## RESPONSE TO REQUEST FOR ADDITIONAL INFORMATION

### APR1400 Design Certification

RAI No.: 68-7892  
SRP Section: 07.07 - Control Systems Not Required for Safety  
Application Section: 7.7  
Date of RAI Issue: 07/10/2015

### **Question No. 07.07-5**

Figure 7.7-5-1 Internal network architectural layout of PCS and other non-safety I&C systems

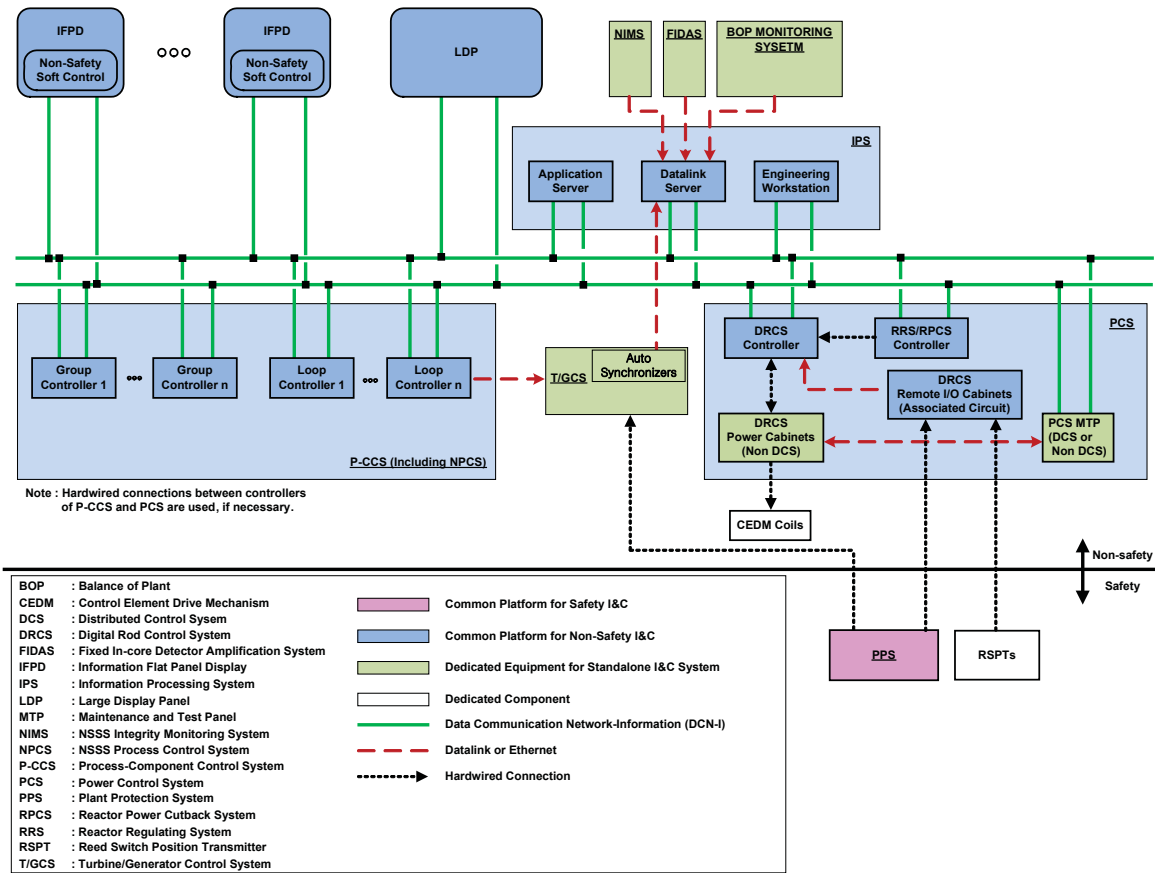
Clarify the network architectural arrangements and interfaces for the individual non-safety I&C systems, with specific attention to those cited in the failure boundary portion of Figure 4.1-1 in Technical Report APR1400-Z-J-NR-14012-P, Rev.0, "Control System CCF Analysis Technical Report."

1. Are there figures illustrating the internal network architectural layout of specific non-safety I&C systems such as the power control system (PCS), as it is described in APR1400 FSAR, Tier 2, Section 7.7? This is critical as the PCS system contains multiple subsystems such as the reactor regulating system (RRS) and the digital rod control system (DRCS).
2. Describe the interface, along with communication type and logic, facilitating the turbine trip function from a reactor trip signal. APR1400 FSAR, Tier 2, Section 10.2.2.3.3, describes the Turbine Generator Control system as a 2-out-of-3 logic system but the Plant Protection System is a 2-out-of-4 logic system.
3. In Figure 4.1-2, "Control System Overview," of Technical Report APR1400-Z-J-NR-14012-P, the acronym, "RRS" (Reactor Regulating System?) is not defined in the drawing key.

1. Figure 4.1-1 in Technical Report APR1400-Z-J-NR-14012-P, Rev 0, "Control System CCF Analysis Technical Report" shows the overview architecture of APR1400 I&C systems. The non-safety I&C system in Figure 4.1-1 represents sets of equipment (such as the IPS server cabinet, the P-CCS group controller cabinet, and the P-CCS loop controller cabinet), depending on their dedicated functions.

In the case of the information processing system (IPS) and the process-component control system (P-CCS), including the NSSS process control system (NPCS), there are no internal dedicated networks for each non-safety I&C system. The data communication network-information (DCN-I) network provides non-safety data communication for these non-safety I&C systems. Refer to APR1400 DCD Subsection 7.9.1.3 and Figure 7.9-1 for additional information about the DCN-I network.

The internal network architecture of the PCS and other communication architecture mentioned in the above description are shown in Figure 7.7-5-1 for information. The PCS MTP can use the common platform for non-safety I&C or dedicated equipment. If dedicated equipment is used, a dedicated gateway will be applied to interface with the DCN-I network. The Control groups of the PCS and the P-CCS are described in Table 4.5-2 in Technical Report APR1400-Z-J-NR-14012-P. Each control group function of the P-CCS in Table 4.5-2 is assigned to at least one group controller or one loop controller.
